MODEL  
2009-2010MY Rio (JB)

NUMBER  
CHA 030

## TECHNICAL SERVICE BULLETIN

RIO (JB) REAR STRUT NOISE REPAIR

*Rio (JB) Rear Strut Assembly*

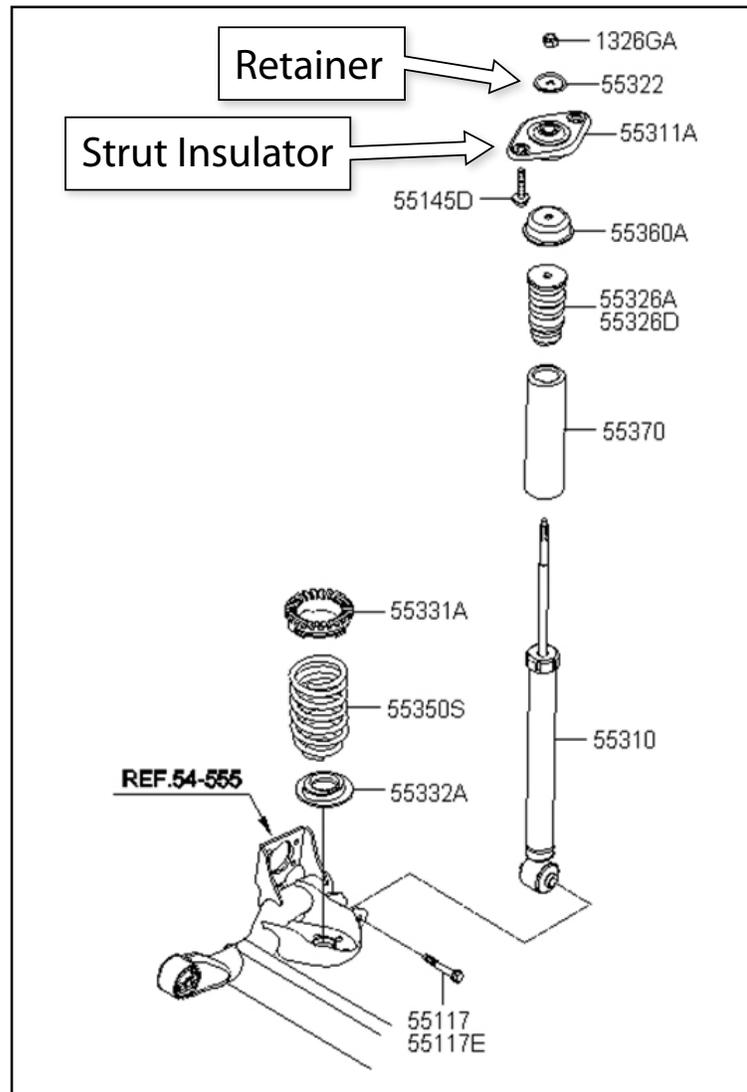
This bulletin provides information relating to Some RIO (JB) vehicles produced from July 1, 2008 to January 27, 2010 that may experience a creaking noise emanating from the rear strut when driving on a rough road in winter weather. To remedy this condition, replace the Rear Strut Insulator and Retainer with improved parts as indicated in the required parts section.

For vehicles with symptom/condition mentioned above; replace the Rear Strut Insulator and Retainer with the improved version according to the applicable workshop manual procedure.

Part Name	Part Number		Figure
A: Retainer	55322 1G000	55322 1C000FFF	
B: Strut Insulator	55311 1G000	55311 1G000FFF
